Product Change Notification - SYST-07LMBO476

ERRATA - SAM D10 Series Family Silicon Errata and Data Sheet Clarifications

SAM D10 Series Family Silicon Errata and Data Sheet Clarification

FIGURE 34-3: BOD33 HYSTERESIS OFF

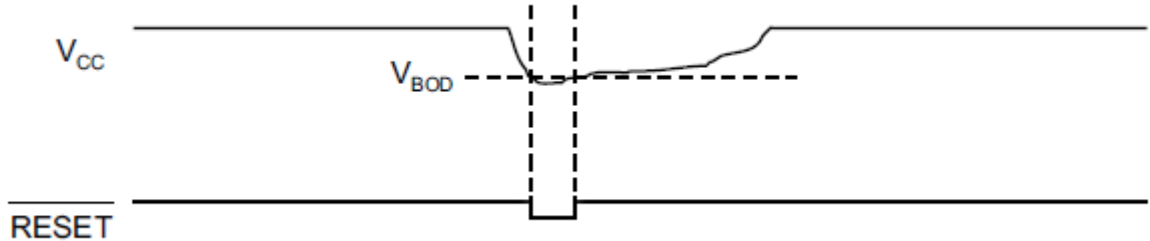
4. Module: Brown Out Detectors Characteristics

Figures 34-3 and 34-4 have an incorrect reset Polarity value. The correct figures are displayed as follows:
